**TREMONTON CITY CORPORATION  
DEVELOPMENT REVIEW COMMITTEE  
APRIL 6, 2022**

a. Discussion and review of Wizard Wash Car Wash – Dan Hart, Bret Cummings, and Jim Flint

SITE & UTILITY PLAN FOR  
WIZARD WASH  
1650 WEST MAIN STREET  
TREMONTON, UT

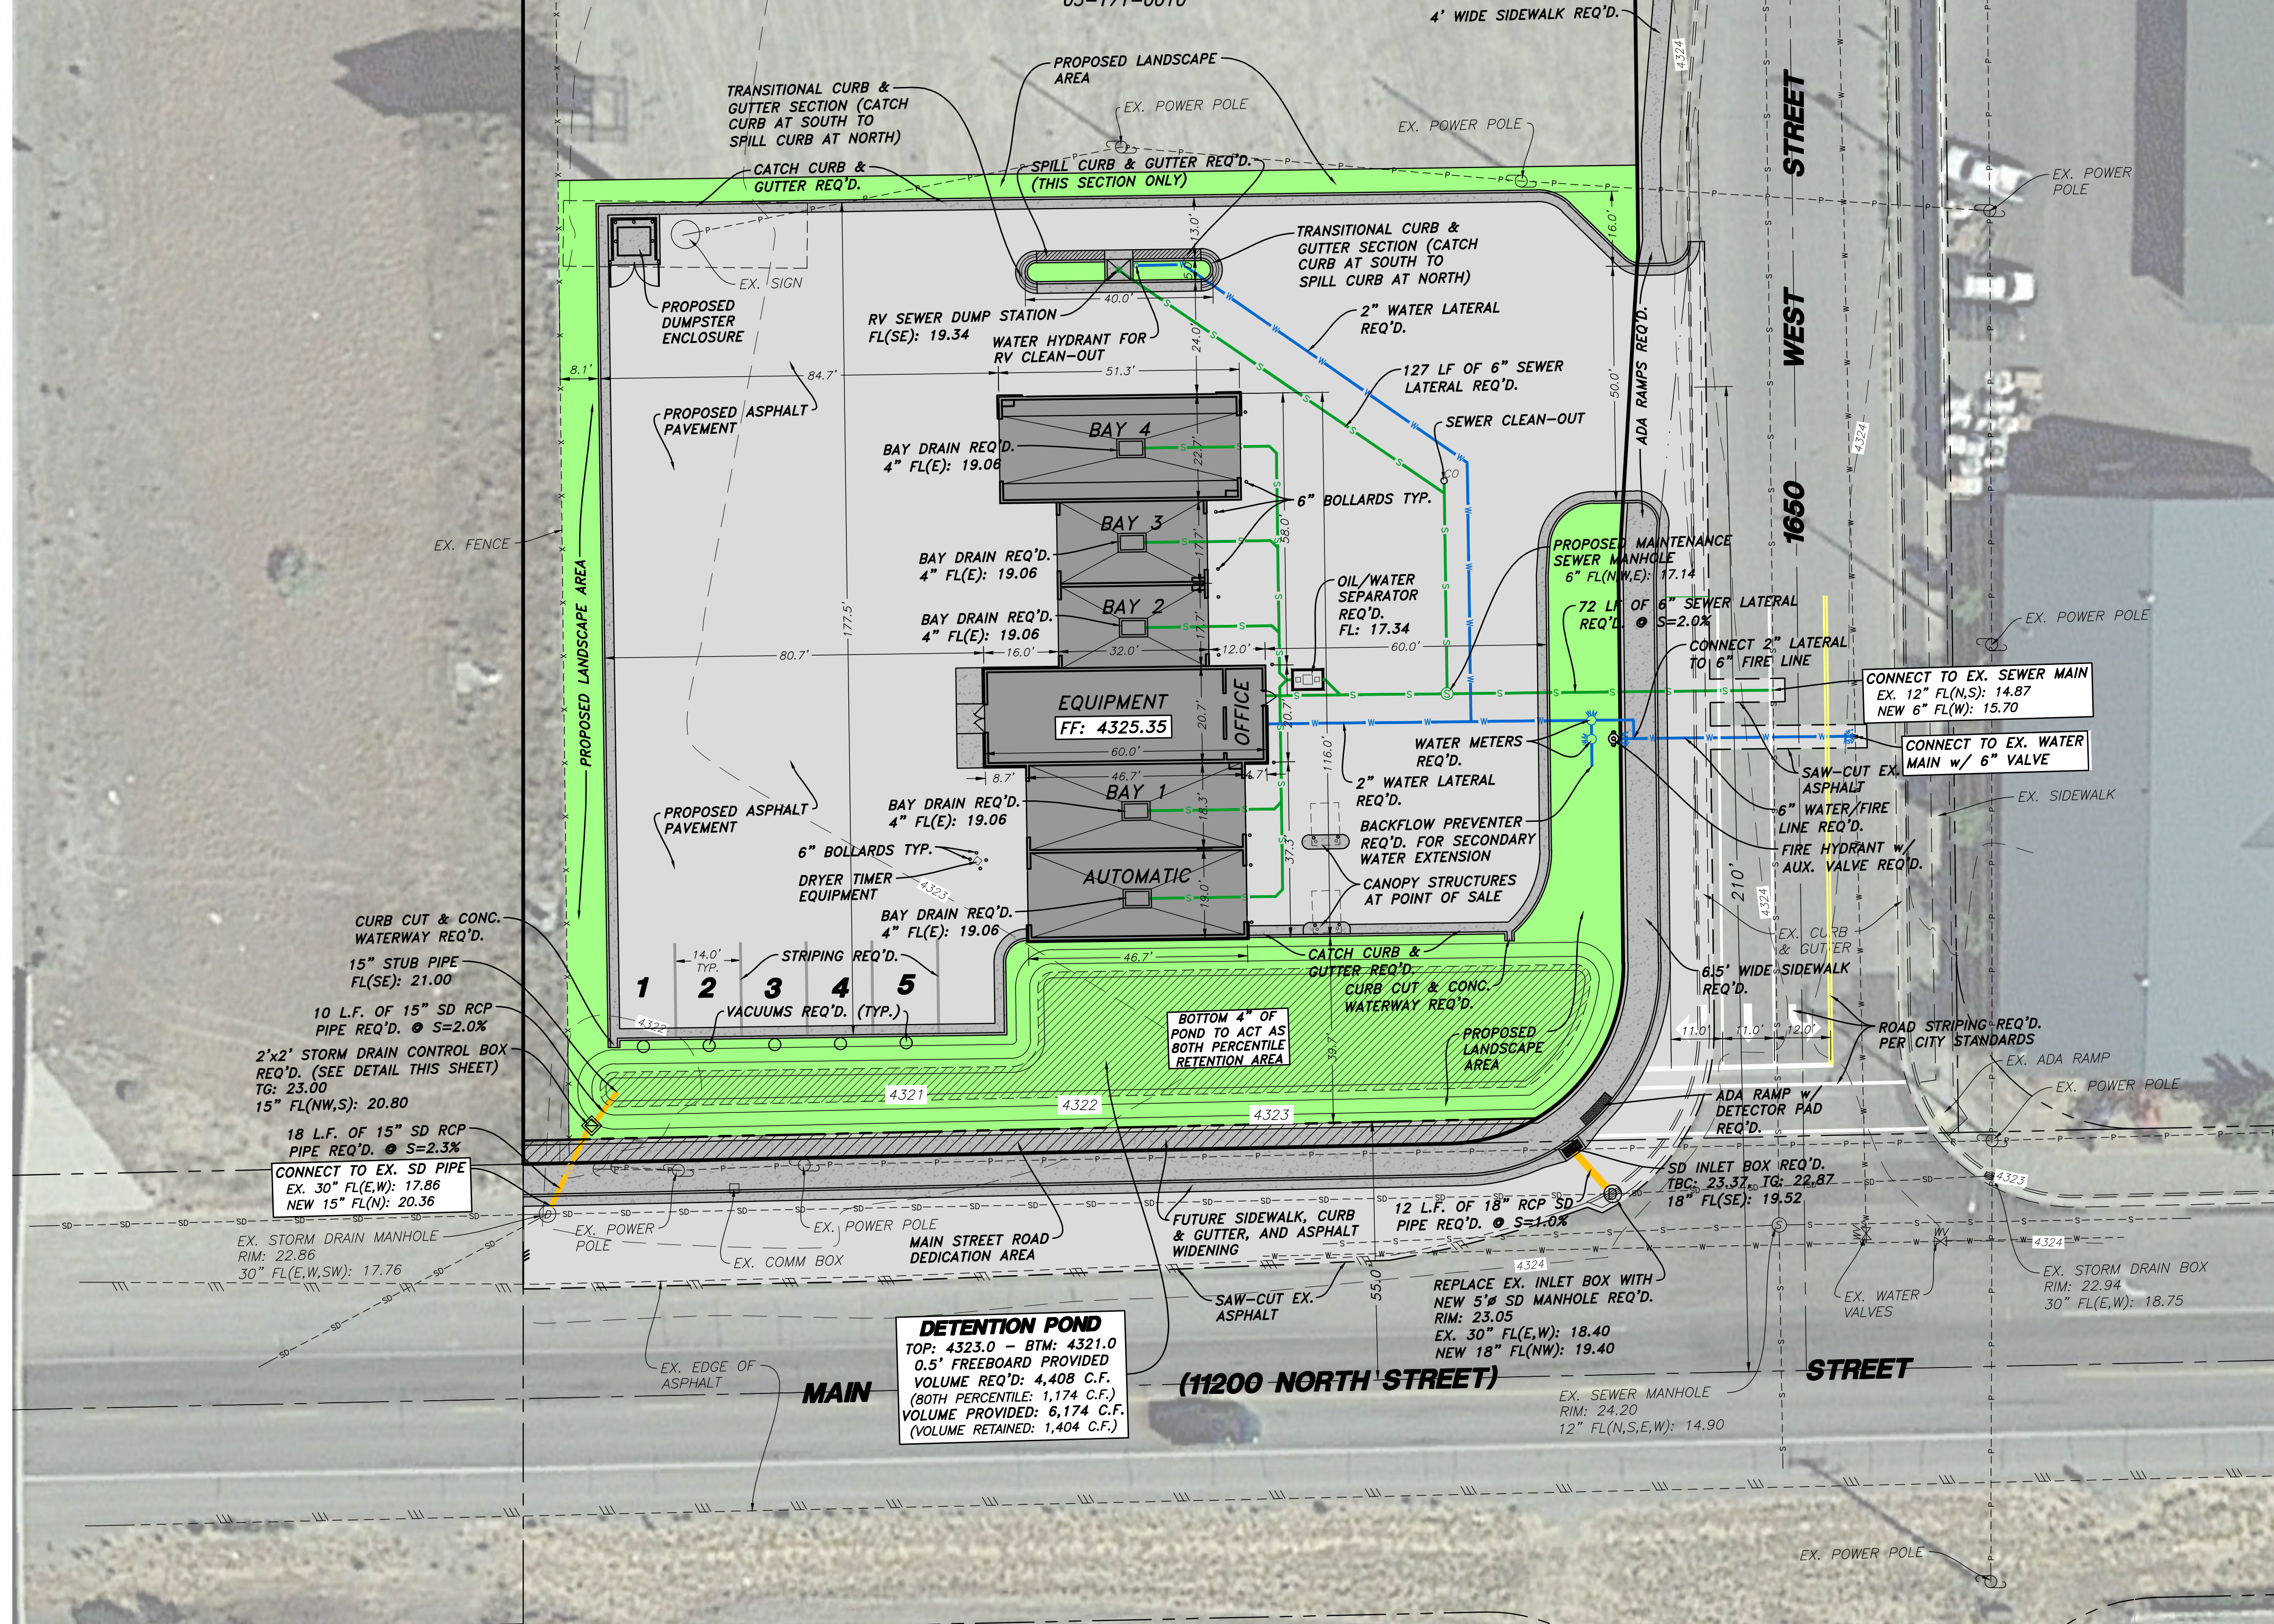
Chairman Bench said the Main Street dedication needs to be applied. Manager Warnke said use the same dedication language and show it for Tremonton City. The Committee asked about the access, which would be shared. The developers said they would prefer a straight drive for trailers to get in and out of 1650 West. They would dump at the RV bay, wash, and the flip around and go back out. Mr. Cummings said we want room to turn so we do not want the vacuums out back they need to be out front. Engineer Breinholt said that will be really tight if cars are waiting to get washed. If you have them lining up to get in, I am not sure how you take care of that unless you use more

property to the north. There is only room for one RV to be waiting behind one that is dumping. They will hang out in the entry way. They need to be in alignment with wash bay 4 and push it to the north. Make that a straight shot. Manager Warnke said you have plenty of property and it looks like you need more room. Mr. Cummings said it will work, but we could push that north side out a bit and add a few more feet. Director Fulgham said that is a wider entrance than we typically do, which I do not mind if it flows.

Manager Warnke reviewed his comments (see attached). The landscape buffer falls really short. I also wondered about having that sign post in the landscaped area so it is somewhat protected. I think there is a better spot for the vacuums, but I understand what you are saying. Our code talks about having dumpsters in the back they are not allowed on the front. Mr. Cummings said the trash receptacles are integrated into the vacuum and mounted on the pole. Manager Warnke said you need something to break up the area. The landscape plan could use more work and have more landscape in the front.

Director Fulgham said the water needs to be brought to the main. You have a valve on the hydrant, but if that ever has to be replaced that would be shut down. You are required to run a two-inch line all the way to the main and tap off that. Then you could do away with the valve by the hydrant. Your meter will be in the main. That way we can work on the hydrant and not worry about pressure. You could do a one-inch landscape meter to save money. You do not want to be charged sewer for your landscaping so that needs to be separate. All water you use inside the bays will have a sewer bill. Engineer Breinholt said this area can do retention, but it cannot release too much at a time because the Mill Ditch cannot handle too much water. They would determine water shares.
